WAUCHULA COMMUNITY REDEVELOPMENT AGENCY  
REQUEST FOR PROPOSALS CRA #22-01  
HISTORIC CITY HALL AUDITORIUM RENOVATIONS PHASE I

ADDENDUM 3

ITEMS SUBMITTED FOR CLARIFICATION

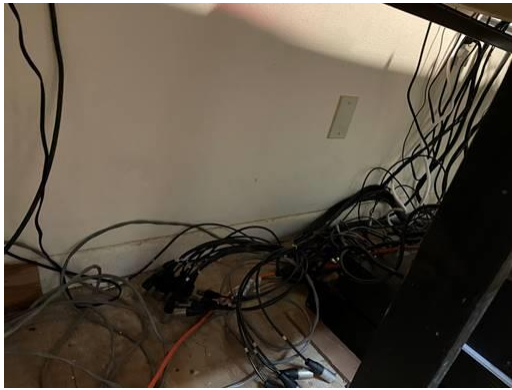
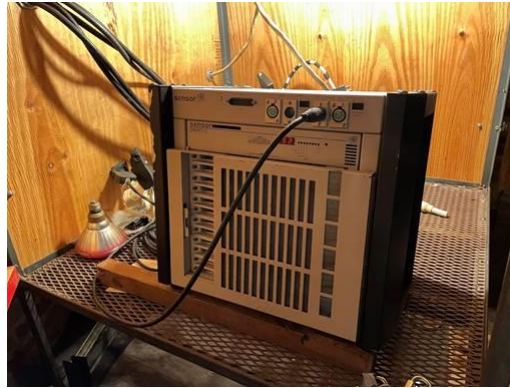
ITEM: Page 24, items 11, 12, 13: Sizes of curtains to be confirmed with drawings. If drawings are not available, client to provide size estimates to the nearest foot which can be confirmed prior to procurement. What hardware, if any, is to remain for the curtain systems?

RESPONSE: Main Traveler: at 44' wide X 18' tall  
Legs: at 19' tall, 10 total  
Border: at 44' wide, 5 total  
Fire Curtain: curtain is in good order and runs up and down fine. However, the emergency drop mechanism is not functional. Also, we want to use the Fire Curtain as a show piece. Consider the original curtain look below or something like the New Theatre Royal Lincoln in the UK.
